# UNITED STATES PATENT AND TRADEMARK OFFICE

### Office Action Summary

10/588,463

VOGELIN ET AL.

**Fig A**

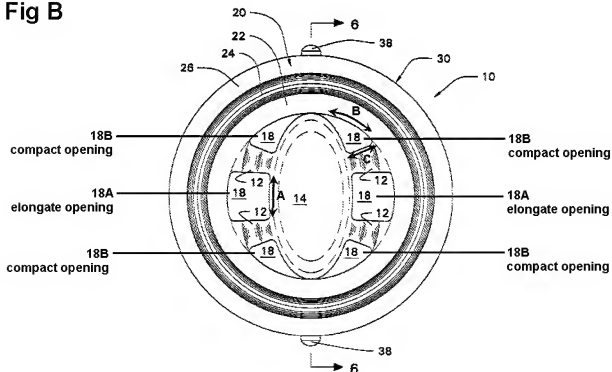
5. Re claim 18, Samson discloses a breast shield set 10 (Fig 1) for pumping off human breast milk, the breast shield set comprising a breast shield 24 (Fig 3), a breast shield connector 30 (Fig 3) with a threaded attachment (Col 3, Line 52) for connection to a milk collection vessel 14 (Fig 3), and a valve 16 (Fig 3) for limiting a dead volume during pumping off of breast milk, wherein the valve has a valve seat 36 (Fig 3) and a valve body 42 (Fig 3) with a circular diaphragm (Col 4, Lines 10-11), the valve body being arranged over the valve seat and closing the valve seat sealingly when it bears on said valve seat (Col 4, Lines 14-18), and the valve seat and valve body having openings (opening 38 in valve seat 36 and "valve body opening" in valve body 42; best shown in Fig A below) which are offset relative to one another (best shown in Fig A below) and which form a free passage when the diaphragm of the valve body lifts (Col 4, Lines 18-24). Samson does not disclose that the diaphragm valve body comprises elongate openings with a long dimension which are uniformly distributed adjacent the periphery of the diaphragm wherein the elongate openings are separated from one another by webs, the diaphragm designed to be weaker in the area adjacent to these webs or that the openings of the diaphragm further comprise compact openings which are present in areas generally between said elongate openings with said compact openings being

smaller than said elongate openings and having a part that extends adjacent said periphery and another part that extends generally radially relative to a center of said diaphragm. Zelson, however, teaches a valve 10 (Fig 2,5) having a valve seat 32 (Fig 2) and a valve body 30 (Fig 5) with a circular diaphragm (formed by pieces 22,12,14 as seen in Fig 5), the valve body being arranged over the valve seat and closing the valve seat sealingly when it bears on said valve seat (Para 76), and the valve seat and valve body having openings (as seen in Fig 2,5) which are offset relative to one another (as seen in Fig 2) and which form a free passage when the diaphragm lifts (Para 76), wherein the valve body comprises elongate openings 18A (best seen in Fig B below) with a long dimension (as noted by double-headed arrow A in Fig B below) which are uniformly distributed adjacent the periphery of the diaphragm (as seen in Fig 5) wherein the elongate openings are separated from one another by webs 12 (Fig 5), the diaphragm designed to be weaker in the area 22 (Fig 5) adjacent to these webs (weaker compared to portion 14 due to the difference in the widths of the portions) and wherein the openings of the diaphragm further comprise compact openings 18B (best seen in Fig B below) which are present in areas generally between said elongate openings (as seen in Fig 5) with said compact openings being smaller than said elongate openings (as seen in Fig 5) and having a part (as noted by double-headed arrow B in Fig B below) that extends adjacent said periphery and another part (as noted by double-headed arrow C in Fig B below) that extends generally radially relative to a center of said diaphragm (as seen in Fig 5 and Fig B below) for the purpose of forming a valve through which fluids may pass regardless of its orientation (Para 74-76). Therefore, it

would have been obvious to one of ordinary skill in the art at the time the invention was made to modify Samson to include elongate openings, webs, and compact openings, as taught by Zelson, for the purpose of forming a valve through which fluids may pass regardless of its orientation (Para 74-76).

9. Re claim 30, Samson discloses all the claimed features except that compact openings are present adjacent to the webs and are arranged in the weakened area of the diaphragm. Zelson, however, teaches compact openings 18B (as seen in Fig B above) adjacent to webs 12 (Fig 5 and Fig B above) that are arranged in the weakened area (the area formed by portions 22 and 12 that are thinner than portion 14, Fig 2,5) of the diaphragm for the purpose of guiding and restrictively permitting the movement of the plugging portion of the valve in order to allow or prevent fluid to pass (Para 55).

Fig A below) which are offset relative to one another (best shown in Fig A below) and which form a free passage when the diaphragm of the valve body lifts (Col 4, Lines 18-24), the valve body having the same basic shaped as the valve seat (both circular as seen in Fig 3). Samson does not disclose that the diaphragm valve body comprises elongate openings which are uniformly distributed along a circle in the periphery of the diaphragm and wherein the elongate openings are separated from one another by webs, the diaphragm designed to be weaker in the area adjacent to these webs or that the valve body comprises the diaphragm and a cylindrical jacket that surrounds the diaphragm, wherein the valve body is a unitary part, and wherein the jacket can be fitted over the valve seat. Zelson, however, teaches a valve 10 (Fig 2,5) having a valve seat 32 (Fig 2) and a valve body 30 (Fig 5) with a circular diaphragm (formed by pieces 22,12,14 as seen in Fig 5), the valve body being arranged over the valve seat and closing the valve seat sealingly when it bears on said valve seat (Para 76), and the valve seat and valve body having openings (as seen in Fig 2,5) which are offset relative to one another (as seen in Fig 2) and which form a free passage when the diaphragm lifts (Para 76), wherein the valve body comprises elongate openings 18 (Fig 5) which are uniformly distributed along a circle in the periphery of the diaphragm (as seen in Fig 5) wherein the elongate openings are separated from one another by webs 12 (Fig 5), the diaphragm designed to be weaker in the area adjacent to these webs (weaker compared to portion 14 due to the difference in the widths of the portions), and wherein the valve body comprises the diaphragm and a cylindrical jacket (as seen in Fig C above) that surrounds the diaphragm, wherein the valve body is a unitary part and has

**Fig C**

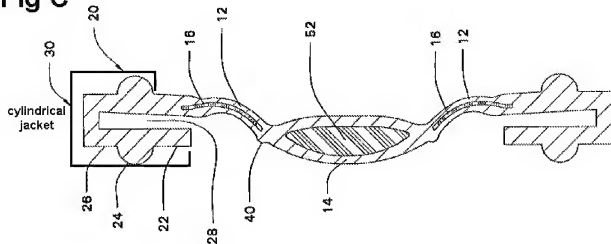
10. Re claims 32-36, Samson discloses all the claimed features except that the valve body has a cylindrical jacket connected circumferentially to the plane disk diaphragm. Zelson, however, teaches that the diaphragm except for the openings and weakened areas is designed as a plane, closed disk (as seen in Fig 5) which is connected circumferentially to a cylindrical jacket (noted as 26 in Fig 5, but best seen in Fig C below) in which the jacket has at least one notch 26 (as seen in Fig 2,3,5) extending parallel to a center axis of the cylindrical jacket (as seen in Fig 2,3,5), in which the jacket has an inner face provided with at least one groove 28 (Fig 3) extending at least partially about the circumference (as seen in Fig 3) and in which the jacket is provided with a bead 24 (Fig 2,3) extending at least partially about the circumference (as seen in Fig 5) for the purpose of holding the diaphragm and the valve seat together (Para 55). Therefore, it would have been obvious to one of ordinary skill in the art at the time the invention was made to modify Samson to include a cylindrical jacket, as taught by

Zelson, for the purpose of holding the diaphragm and the valve seat together (Para 55).
